**LIGO**  
 CALIFORNIA INSTITUTE OF TECHNOLOGY  
 MASSACHUSETTS INSTITUTE OF TECHNOLOGY

**LIGO-0961722-02-0**  
 LASER INTERFEROMETER  
 GRAVITATIONAL-WAVE OBSERVATORY  
 ROUGH GRADING - LIVINGSTON, LA  
 AS NOTED PP150969 8094  
**RG-C-016**

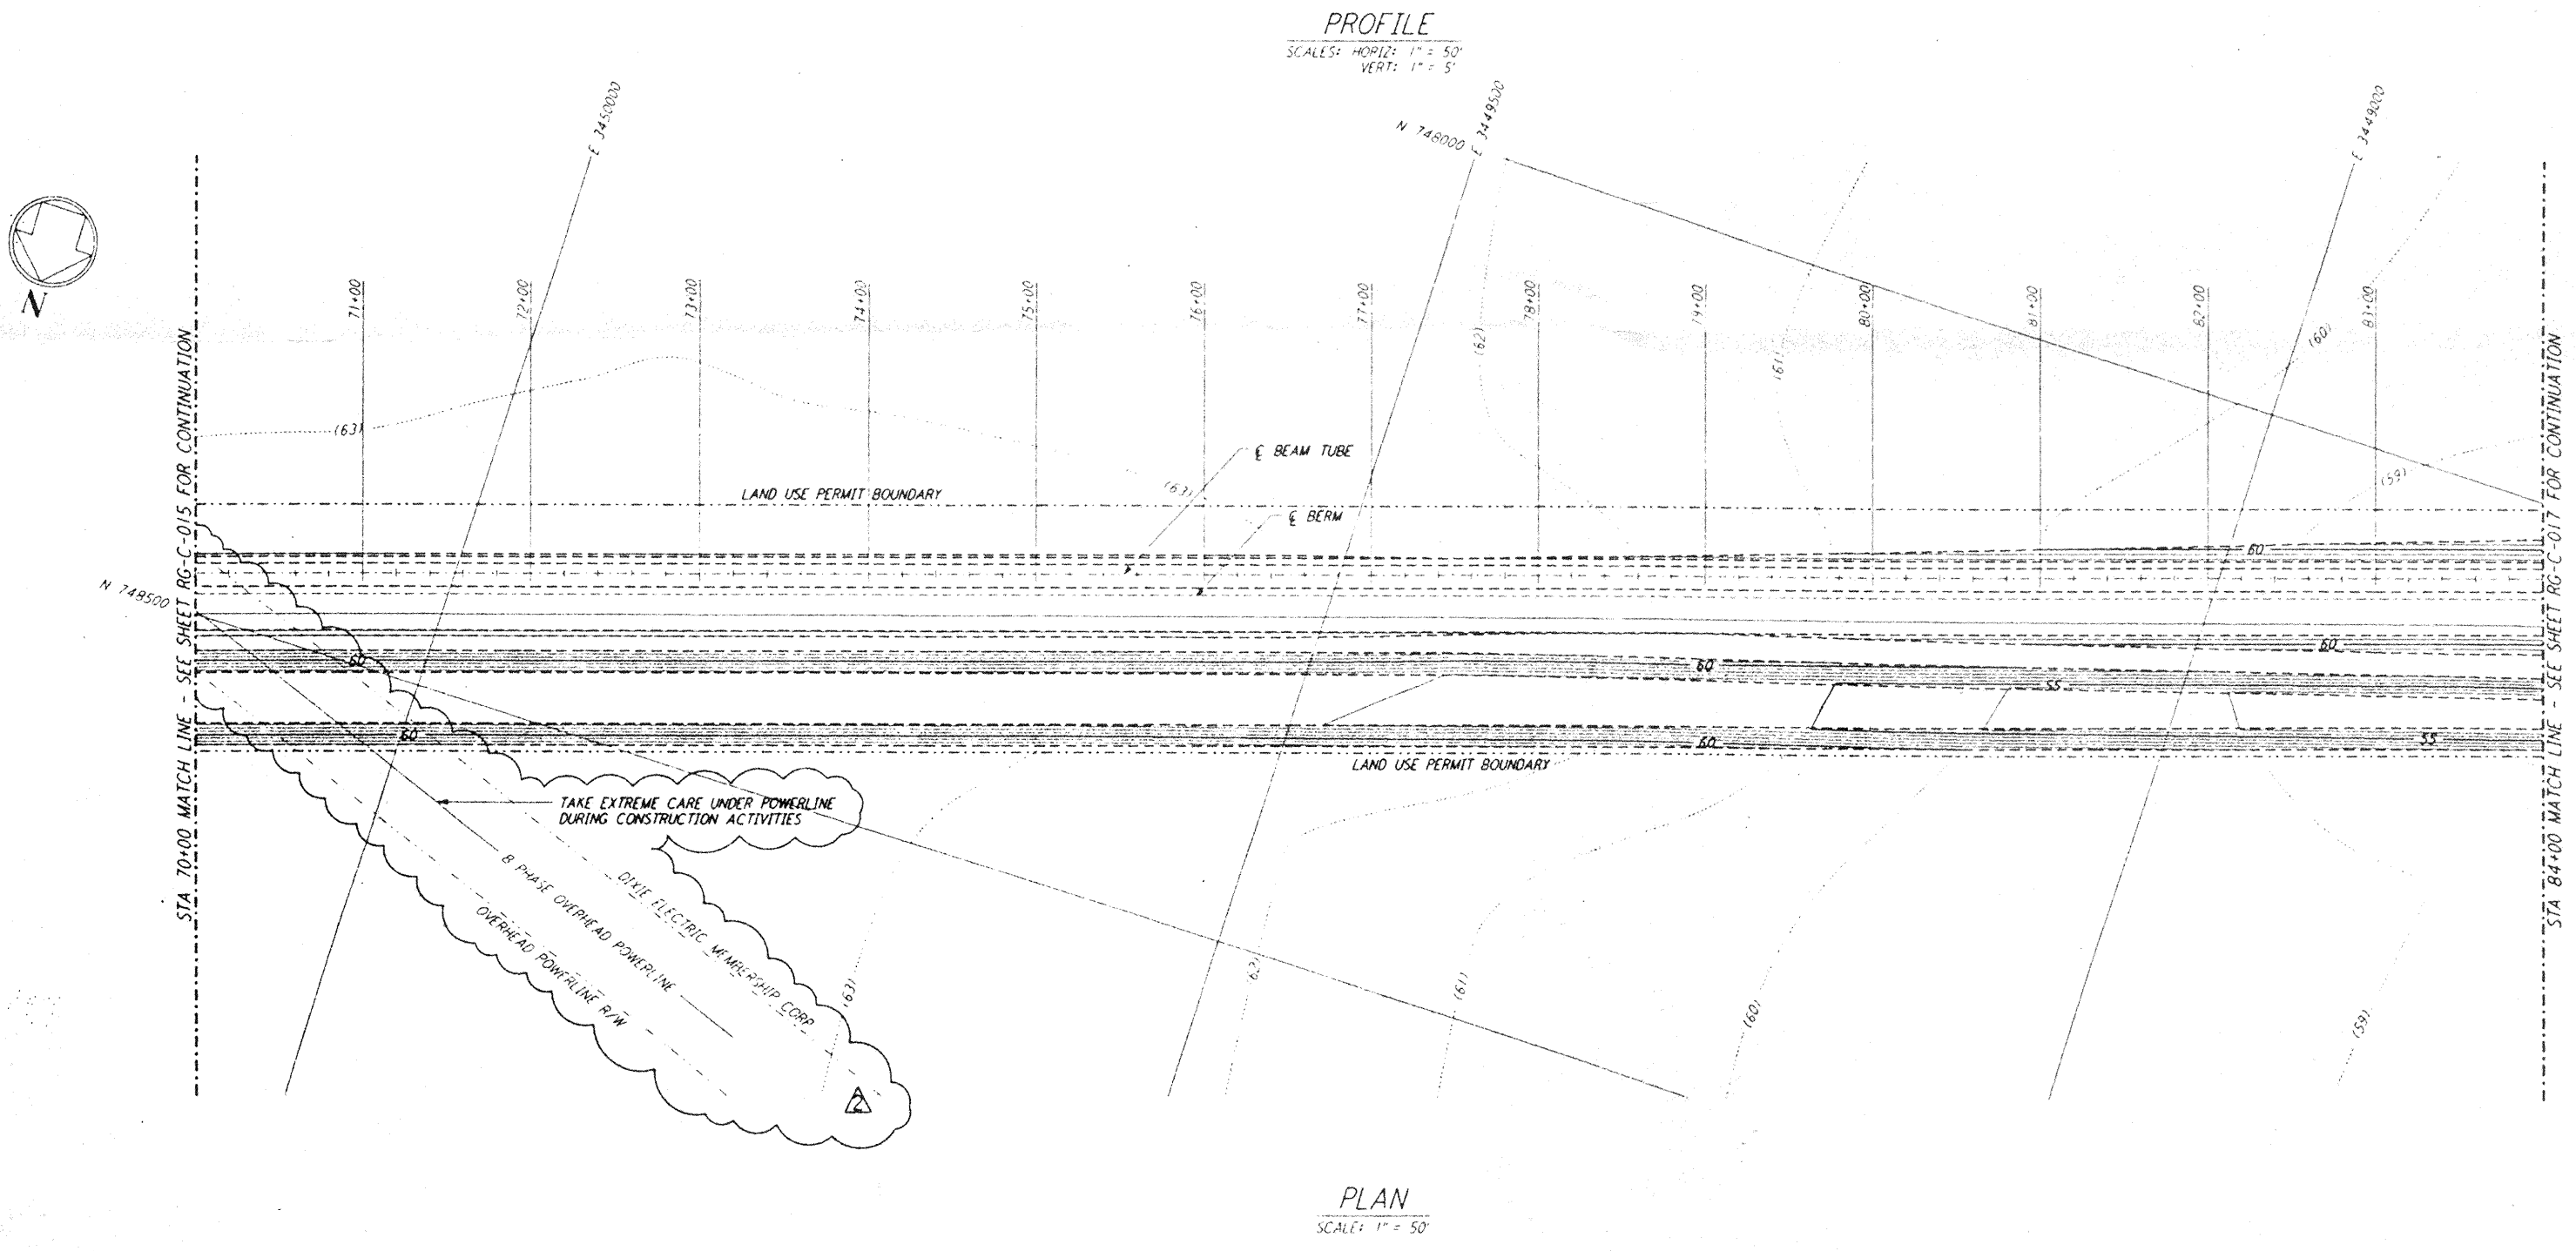
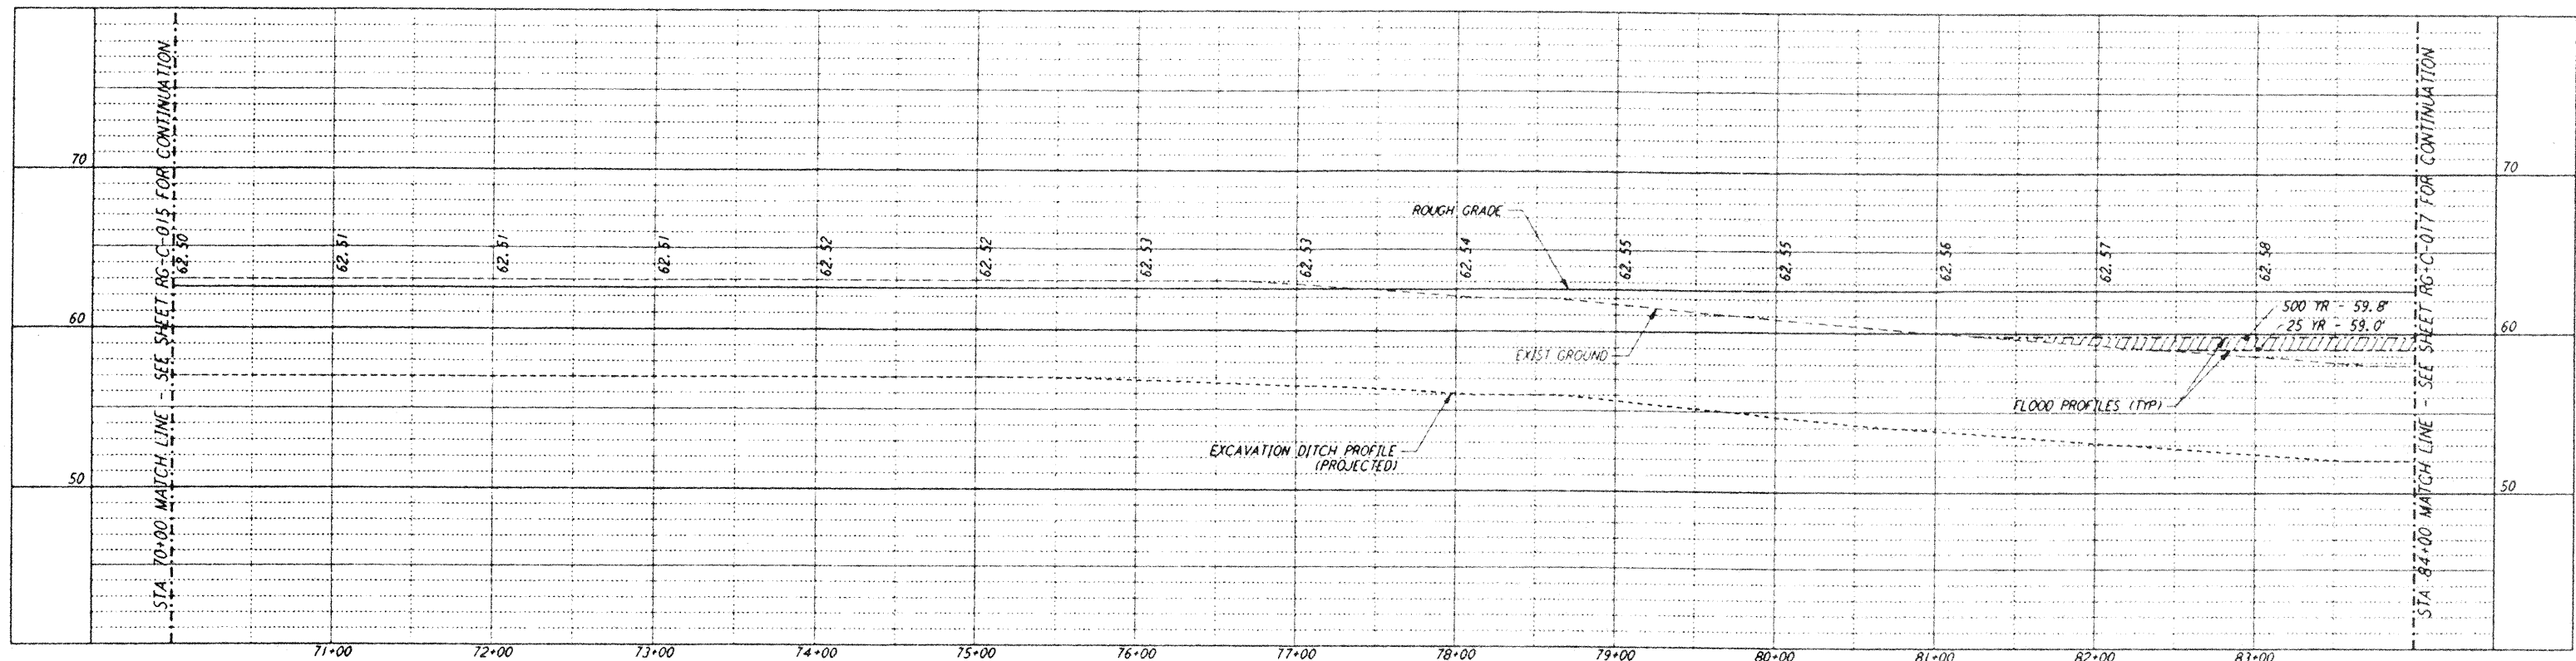
NO.	DATE	APPRO BY	DESCRIPTION OF REVISION
9			
8			
7			
6			
5			
4			
3	5/24/96	Tom	REVISED OVERHEAD POWERLINE R/W LOCATION
2	11/1/95	Tom	NO REVISIONS
1	8/28/95	Tom	ISSUED FOR BID

NO.	DATE	APPRO BY	ISSUED FOR
9			
8			
7			
6			
5			
4			
3	5/24/96	Tom	CHANGE ORDER NO. 6
2	11/1/95	Tom	ISSUED FOR CONSTRUCTION
1	8/28/95	Tom	ISSUED FOR BID
